# Marine Diving Solutions.

# Juniata Reservoir Outlet Valve Replacement Project as-builts September through November 2021

# JUNIATA RESERVOIR DAM

JUNIATA RESERVOIR  
TYPICAL SECTIONS

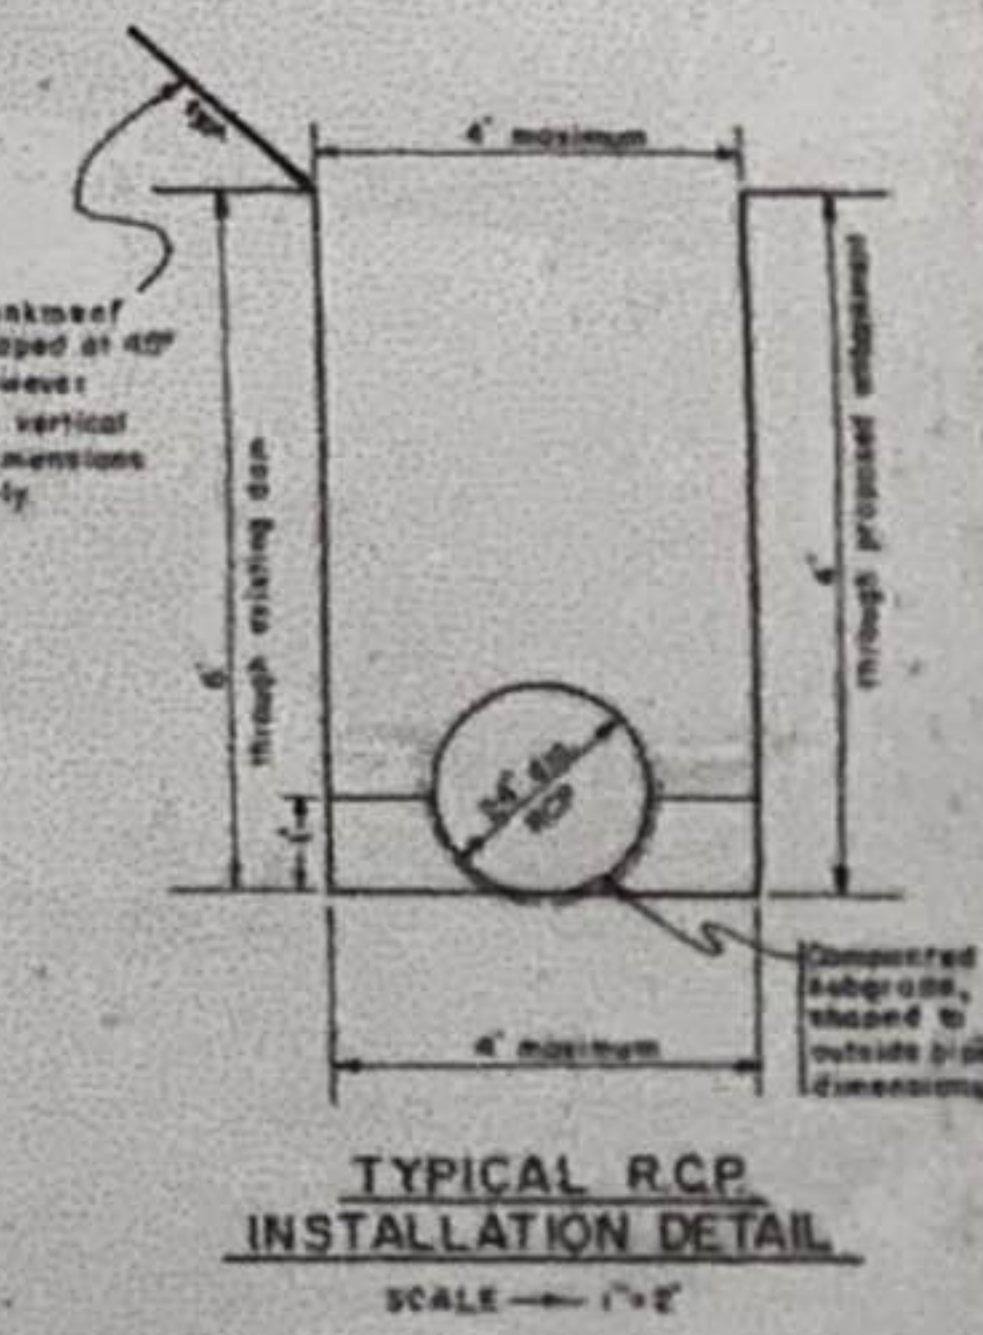
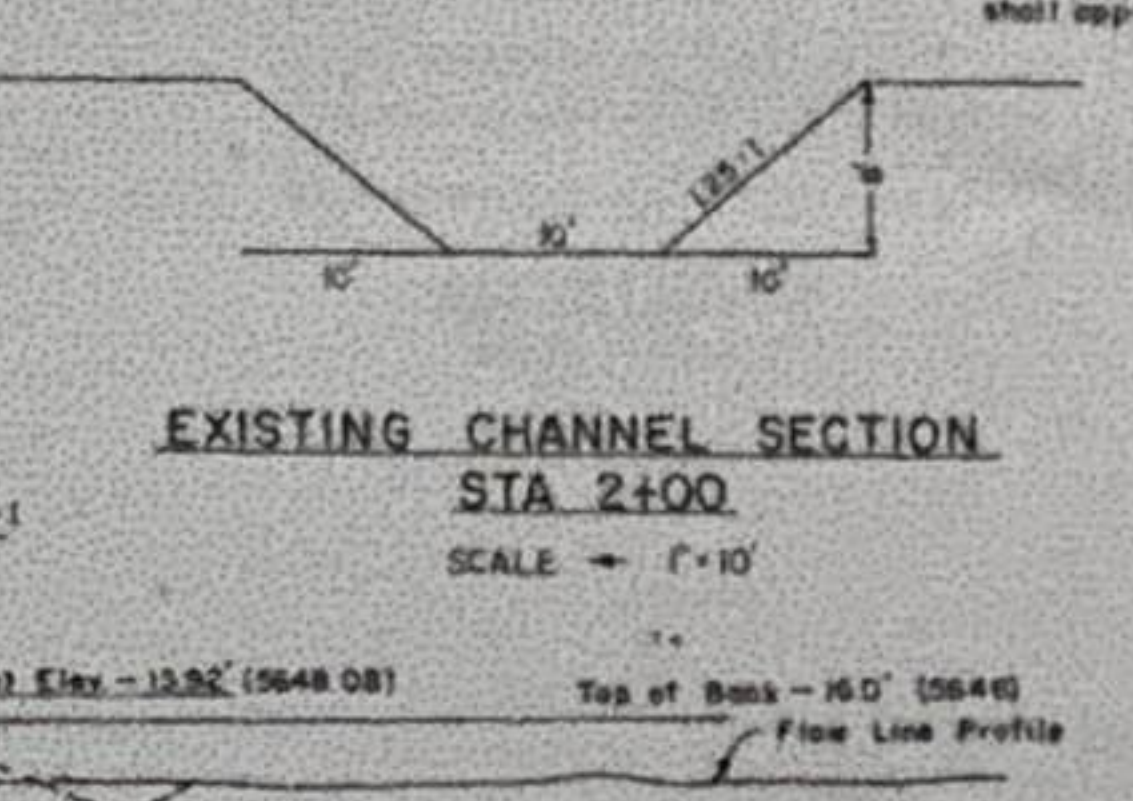
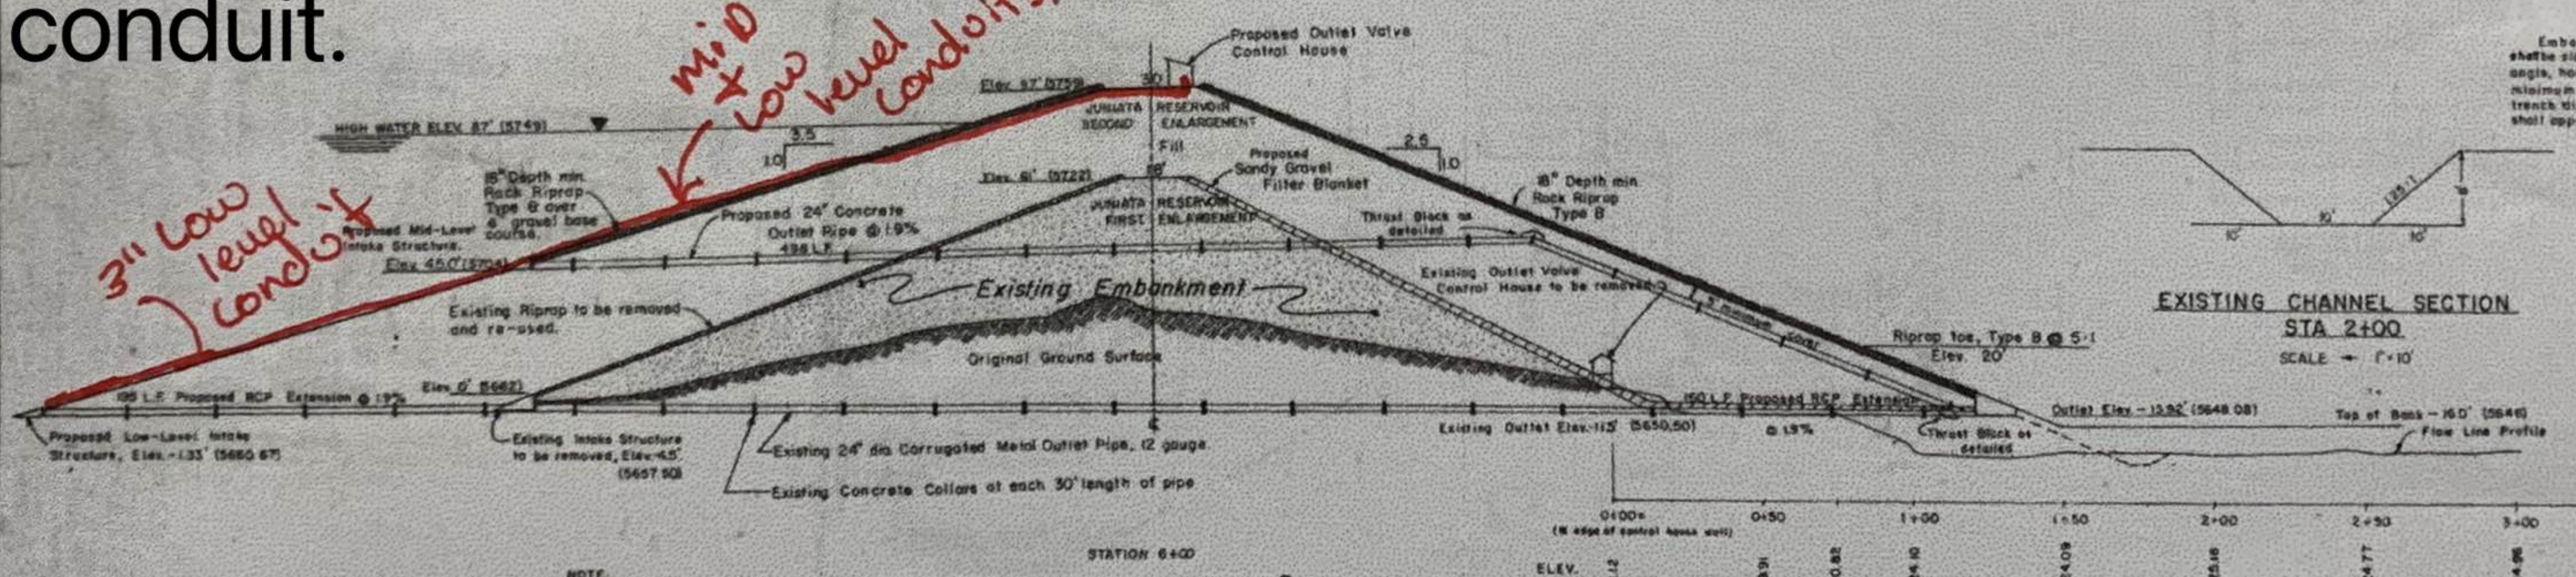
3" Schedule 40 galvanized steel pipe was used for the new conduit.

**JUNIATA RESERVOIR**  
VALVE DETAILS  
OUTLET DETAILS

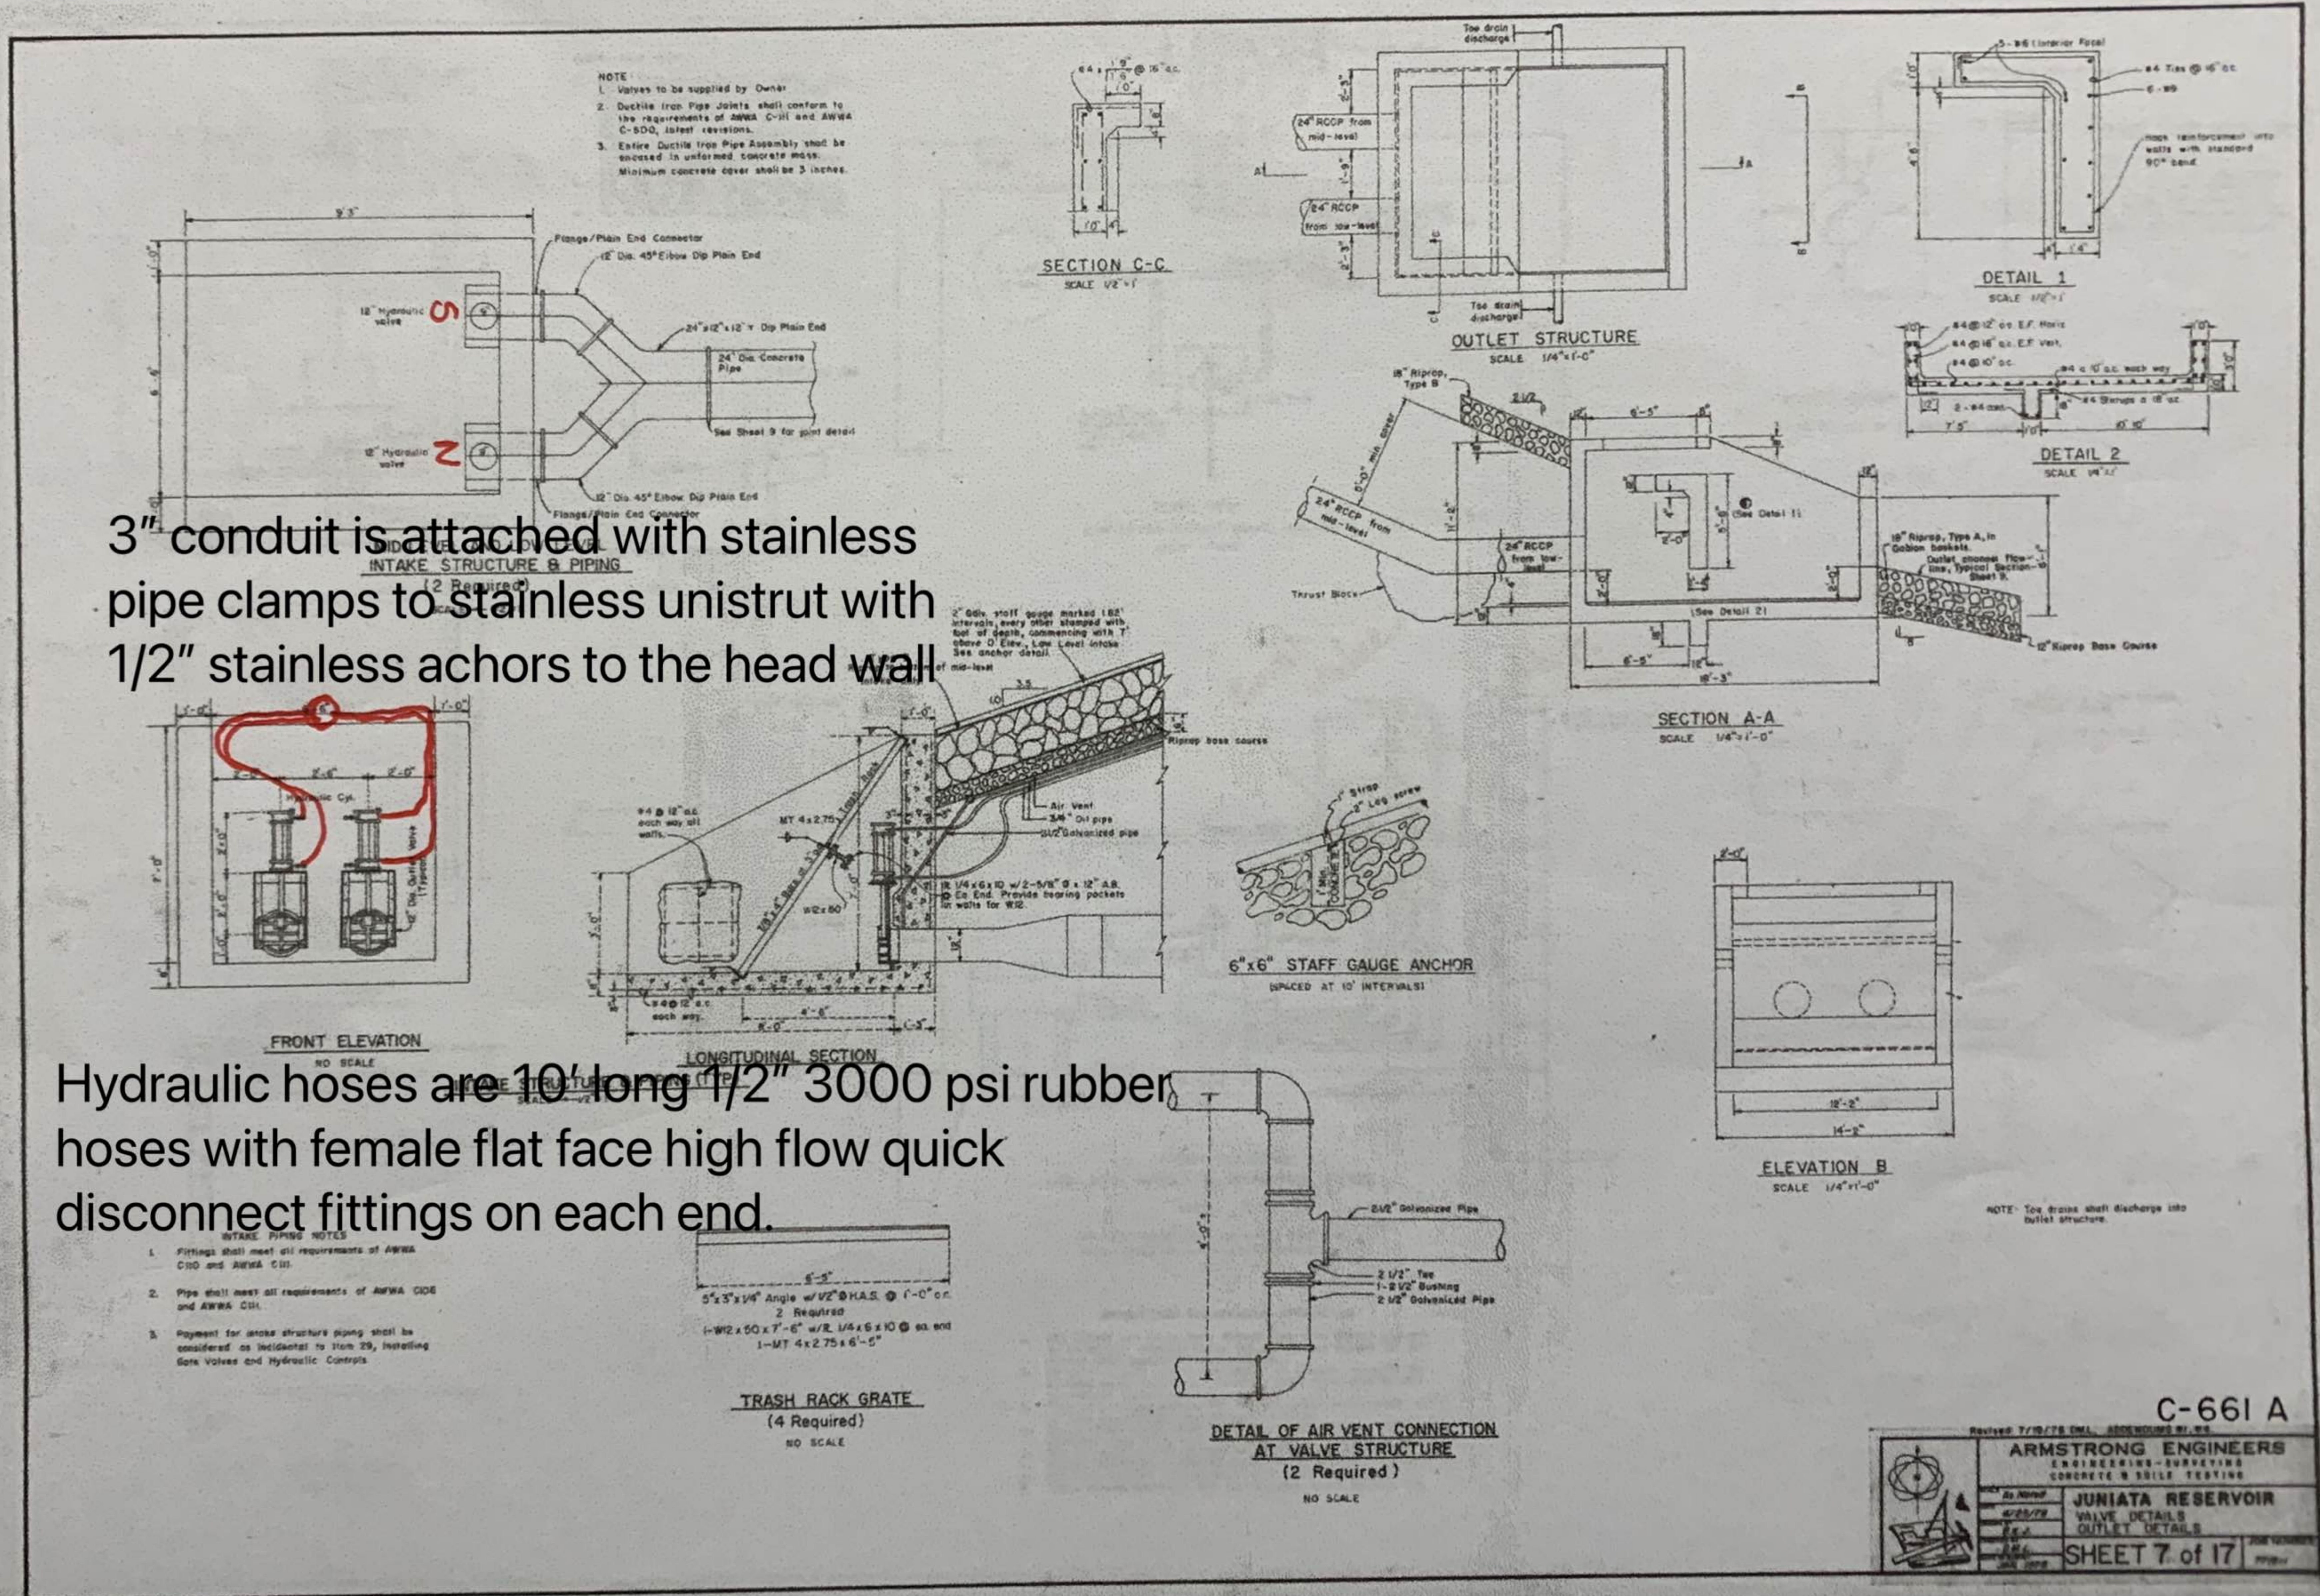
# New 12" VSI Waterworks gate valves with VSI Waterworks hydraulic actuators. Installed 10-22-21

3" conduit is attached with stainless pipe clamps to stainless unistrut with 1/2" stainless anchors to the head wall

Hydraulic hoses are 10' long 1/2" 3000 psi rubber hoses with female flat face high flow quick disconnect fittings on each end.
